**Replacement Pages for ANUH-01.0150, the Standardized Advanced
NUHOMS[®] UFSAR, Revision 3 (Public Version)**

UPDATED FINAL SAFETY ANALYSIS REPORT
FOR THE
STANDARDIZED ADVANCED NUHOMS®
HORIZONTAL MODULAR STORAGE SYSTEM
FOR IRRADIATED NUCLEAR FUEL

Revision 3 of this UFSAR incorporates modifications implemented per 10 CFR 72.48 from August 16, 2006 through August 15, 2008. This revision also includes a full list of effective pages.

Figure A.4.7-9
Time to Reach Boiling Conditions inside 24PT4-DSC Cavity

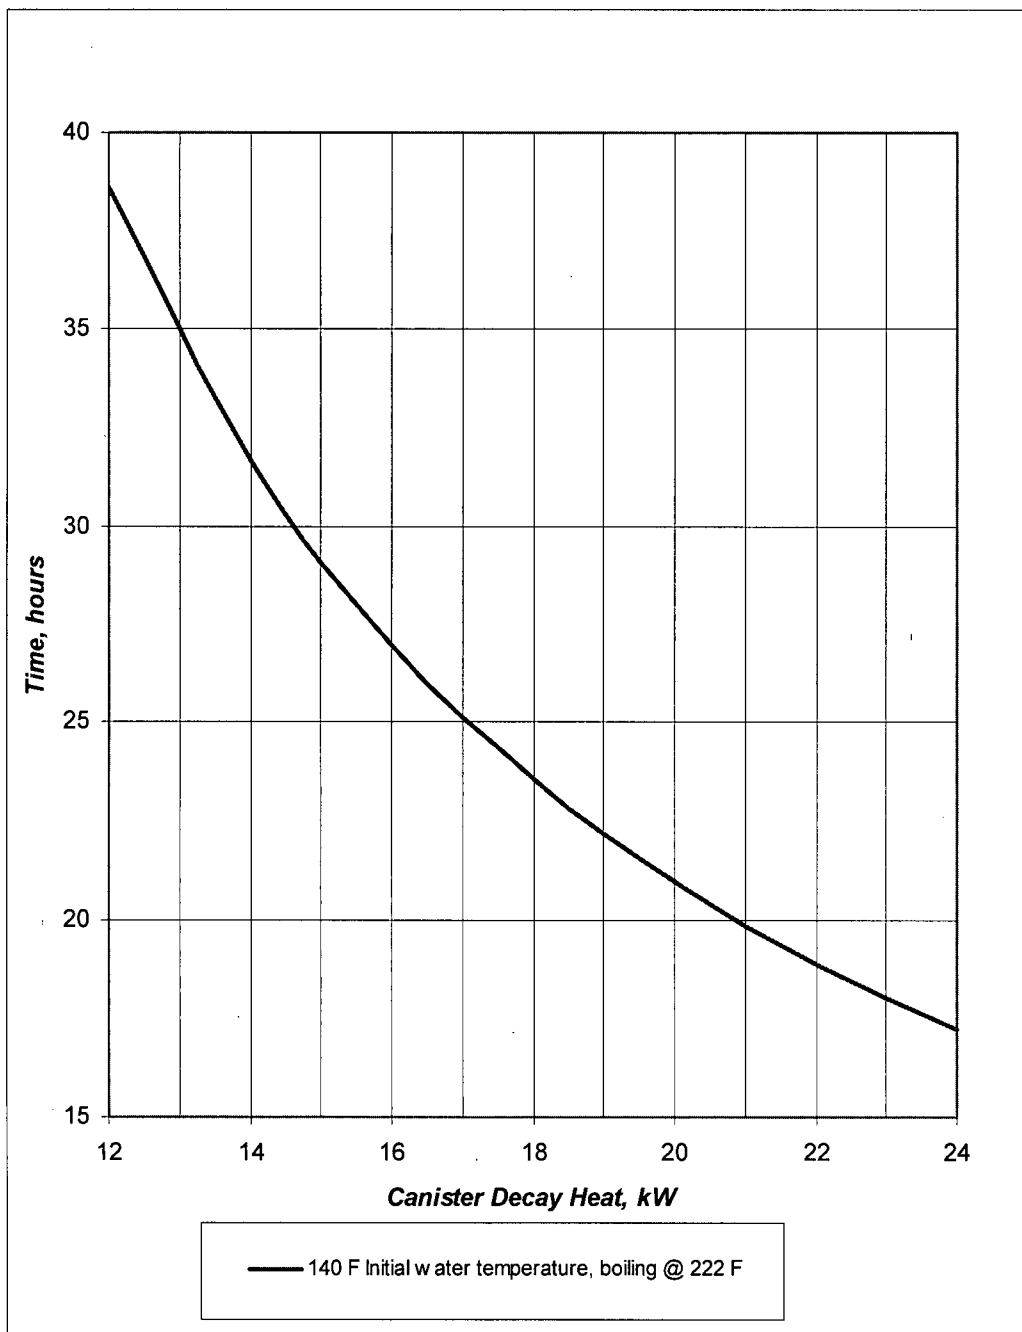
* Time is to be conservatively measured from the time that the first assembly is loaded in the DSC to account for heatup of water in the DSC while still in the spent fuel pool.

Figure A.8.1-1
Advanced NUHOMS[®] System Loading Operations Flow Chart
 (continued)

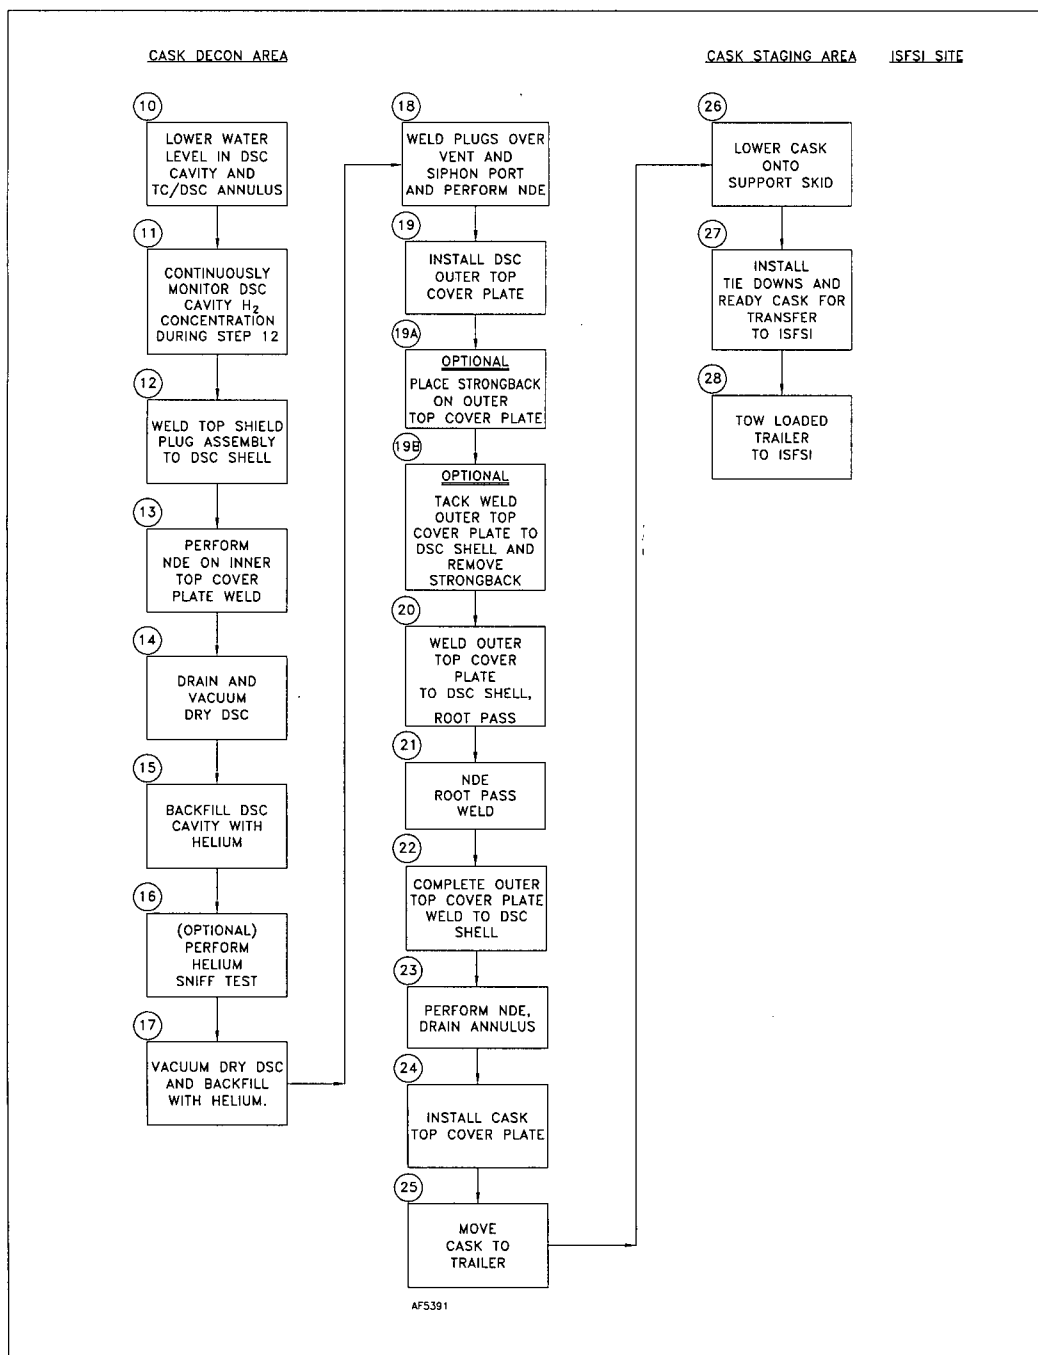
NOTE: *At Licensee discretion a Strongback may be installed on the outer top cover plate to flatten the plate. This will require that the outer top cover plate to the 24PT4-DSC shell tack welds be made manually, as the AWS will not fit over the Strongback. Remove the Strongback after tack welding and install AWS prior to placing the outer top cover plate-weld root pass.*
